SERVICE BULLETIN

Inspection and/or replacement of expansion tank assy. for ROTAX® 912, 914, 912 i, 915 i and 916 i (Series) Aircraft Engines

ATA System: 75-20-00 Expansion Tank

Fig. 1

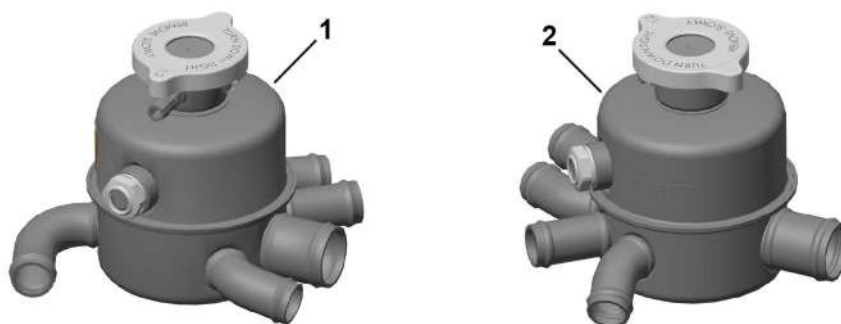
Due to a deviation in the manufacturing process, the individual components of the expansion tank assy. may not be sufficiently welded. Sealing of the assy. may be compromised and coolant leakage and subsequently an overheating of the engine may occur.

Fig.1/ pos.	part no.	Qty/ engine	Description
1	922668	(1)	EXPANSION TANK ASSY.
2	922666	(1)	EXPANSION TANK ASSY.
-	-	AR	COOLANT (as specified in the latest Service Instruction SI-912-016, SI-914-019, SI-912 i-001, SI-915 i-001,SI-916 i-001)
